Problem B:

Power and Timing Optimization Using Multibit Flip-Flop

Sheng-Wei Yang, Jhih-Wei Hsu, Yu-Hsuan Cheng, Cindy Chin-Fang Shen
(Synopsys, Inc.)

Q&A

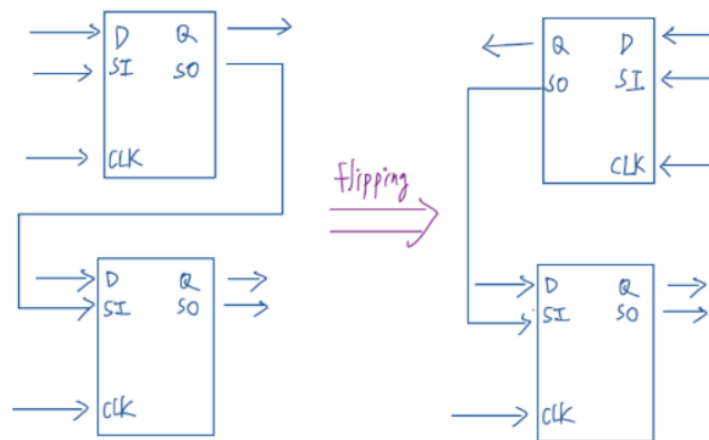
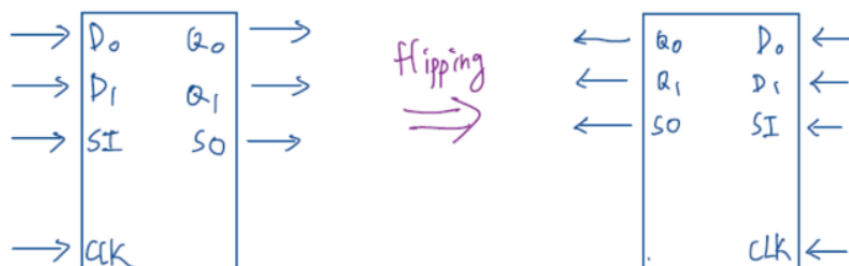
Q5a. Can the pins of the flipflop be flipped as shown in the examples below?

Case 1: flip a single bit FF (the top one)

Case 2: flip all the pins of a MBFF

Case 3: flip the partial pins of a MBFF

A5a. We allow cell flipping as long as cells could be placed legally.

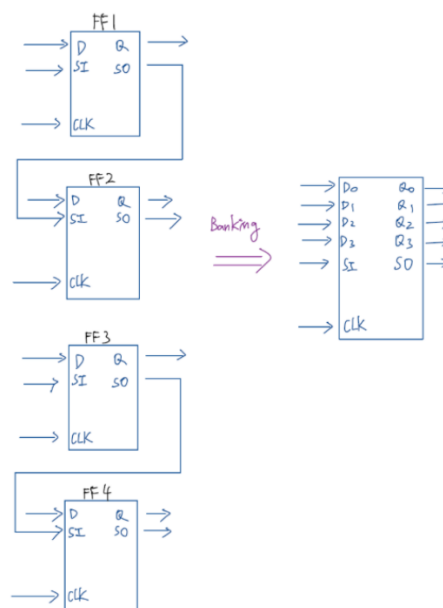
Q5b. Does it mean that the pin locations relative to a flip-flop from the input file can be modified (i.e., the output pin locations can differ from the input) to implement "flipping"?

Or is there an attribute to indicate whether the FF has been flipped in the output file?

A5b. Yes. Please refer to LEF DEF format on how to reflect a flipped cell solution.

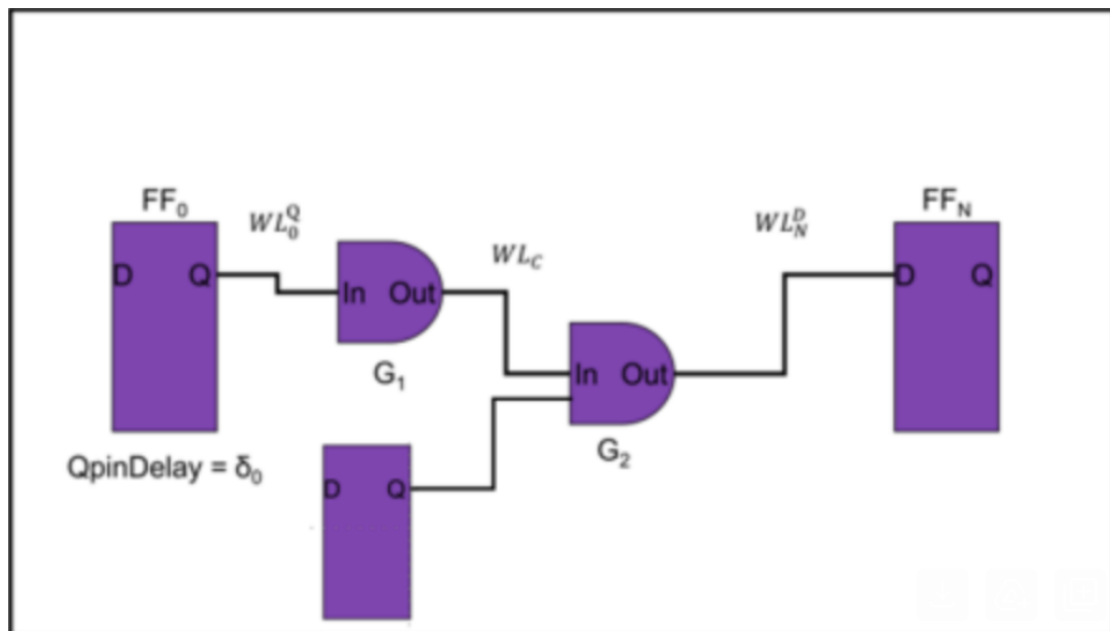
Q10. The problem statement says "All instances must be placed on-site and within the die region." However, it is not explicitly stated whether the die region size or placement row/site information will be included as part of the input.

Will the die area and legal placement sites be provided via the LEF/DEF input files?

Is there any additional information about site dimensions or die boundaries we should be aware of?

A10. Yes. The die area and legal placement sties will be provided via the input files. The legality of contestants' submission, along with the cost metrics, would be evaluated with the latest version of Synopsys Fusion Compiler.
